***Design Review Board Case # 20-0003***  
***Blocks 4&5 – Carlyle Crossing Coordinated Sign Plan***

<b>Application</b>	<b>General Data</b>	
<b>Project Name:</b> Carlyle Crossing Coordinated Sign Plan Special Use Permit  <b>Location:</b> Blocks 4 & 5 – Eisenhower East 2410 and 2460 Mill Road  <b>Applicant:</b> HTC 4/5 Project Owner LLC	<b>DRB Date:</b>	February 25, 2021
	<b>Site Area:</b>	5.07 acres
	<b>Zone:</b>	CDD #2
	<b>Proposed Use:</b>	Residential, Retail, Parking
	<b>Gross Floor Area:</b>	1,021,711 sf
<b>Purpose of Application:</b> DRB review and approval of a Coordinated Sign Plan for the Carlyle Crossing mixed-use project. The plan proposes a program of design guidelines, principles, and regulations for signage to include street- and upper-level retail signage, residential identity signage, and other site signage.

**DRB ACTION FOR FEBRUARY 25, 2021 WORK SESSION - SUMMARY:**

**Figure Above:** Proposed brand-lettering applied to architectural encroachment at Carlyle Crossing

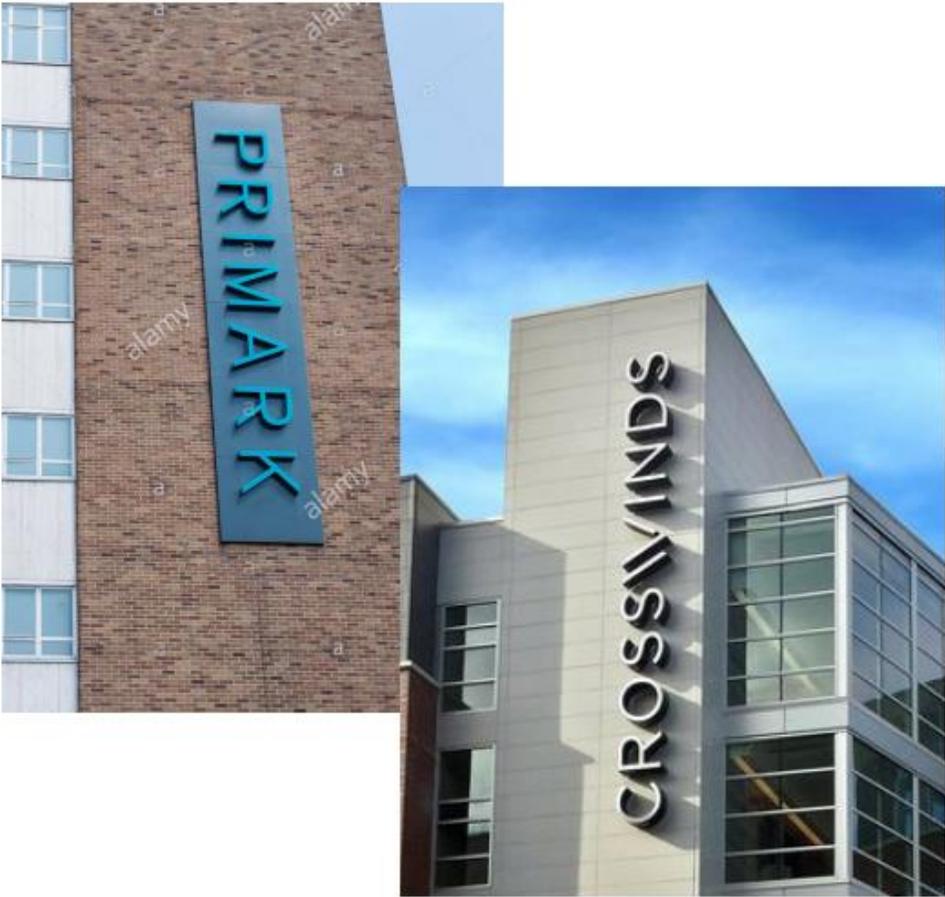
The Applicant is proposing approximately 6,800 square feet of signage above 35-feet, primarily at the third retail level, at a requested ratio of 2:1. This figure is inclusive of the blade signs on Stovall Street (1,070 square feet). Per recent consideration with the Planning Commission and City Council for the North Potomac Yard development, this ratio appears to be acceptable given the scale of the development. Carlyle Crossing is a unique in that it is a retail focused high-rise development. The retail “experience” is concentrated in a symmetrical courtyard located at the northern terminus of Swamp Fox Road and radiates throughout multiple levels of the entire site. Given the pedestrian and retail focus, bold and architecturally responsive signage is necessary in order to create a unique sense of place and serve as wayfinding. Staff researched other relevant examples, including the Potomac Yards CSP SUP#2020-0043, which also supported increased signage ratios due to scale, programmatic focus and elevated architecture. Staff encourages the Applicant to continue refining how the signage integrates with the building architecture to further the creation of an unique place in the City. As with the Potomac Yard SUP, there is an expectation for high-

**Figure Above:** Skyline studies from present submission

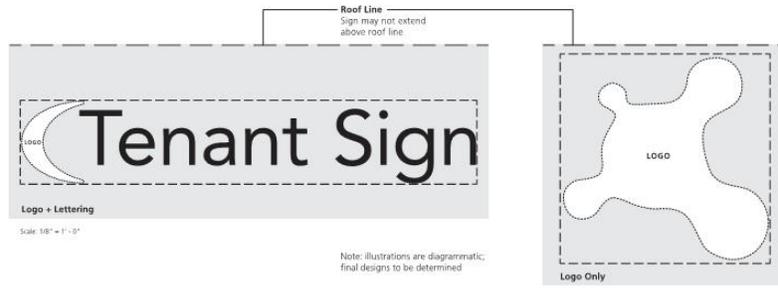
With this submission, the Applicant has refined the design and placement of the skyline signage, which, aside from the grocer, are a signature branding element for the block's redevelopment. A fourth skyline sign has been added to the Western tower and architectural studies demonstrating the proposed composition were also included. The Applicant has also provided further detail that clarifies the place of this element within the architecture of the building. Previously, Staff expressed concern regarding the requested volumetrics and dimension. However, the Applicant has provided more direction on the specific lettering and "programming" within the requested volumes – which Staff now generally recognize as acceptable.

Staff find that the pin-mounted signage included with in the submission scales more elegantly with the building and its architectural elements. The unique branded image above the lettering also relates to the signage for same at the pedestrian entrance of building. As such, these images and letters help create both a unique sense of place that ties the building to the greater development, while simultaneously marketing the site from both near and afar. The design solutions proposed on the buildings are appropriate, however Staff do not believe the design precedent provided in the sign guidelines and shown immediately below would be appropriate for inclusion. The

background does not fit with the architectural aesthetic that was otherwise been developed for the building .
